SERVICE INFORMATION NO. SI 40-023

Diaphragm-Type Fuel Pump Inspection/Replacement
ATA-Code: 73

DATE: August 31, 2005 Service Bulletin No. 548A
(Supersedes Service Bulletin No. 548)

SUBJECT: Diaphragm-Type Fuel Pump Inspection/Replacement

Figure 1

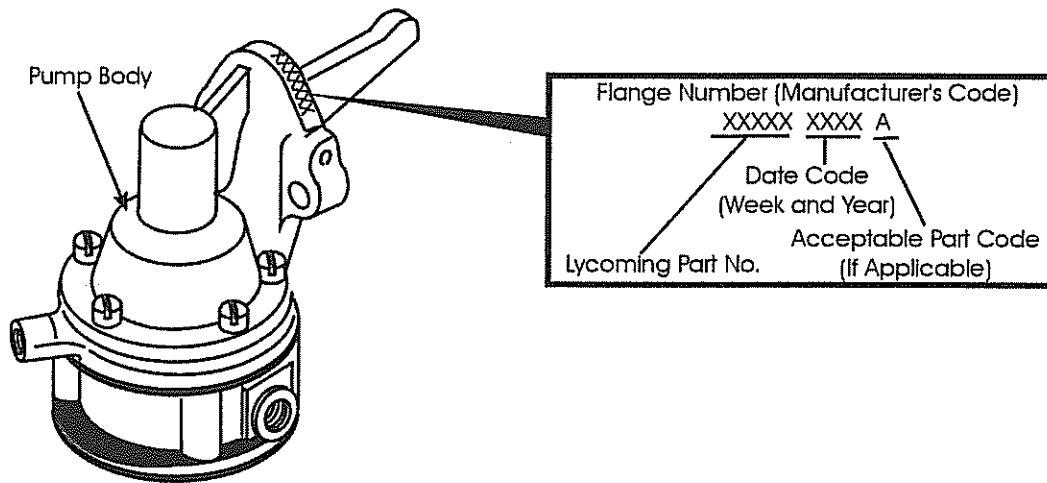
To identify affected pumps, check the manufacturer's code scribed on the flange of the pump (See Figure 1). If the first five digits are 15399, 15472, 15473, or 16335, and the 6th through 9th digits are 0700, 0800, 1100, 1200, 1300, 1400, 1500, 1600, 1800, 2000, 2100, 2200, 2300, 2400, 2800, 2900, 3000, 3100, 3200, 3300, 3400, 3500, 3600, 3700, 3800, 3900, 4000, 4100, 4200, 4300, 4400, 4500, 4600, 4700, 4800, 4900, 5000, 5100, 5200, 0101, 0201, 0301 or 0401, the pump is affected and must be replaced.

If the letter "A" is marked as a suffix to the date code, the pump has been brought into conformity and need not be replaced.

If your Lycoming engine has a diaphragm-type fuel pump with Lycoming P/N LW-15399, LW-15472, LW-15473, or LW-16335 installed, and has a date code of 0700 through 0401, the pump must be replaced within the next 100 hours of operation or 180 calendar days from the date of this Service Bulletin, whichever occurs first.
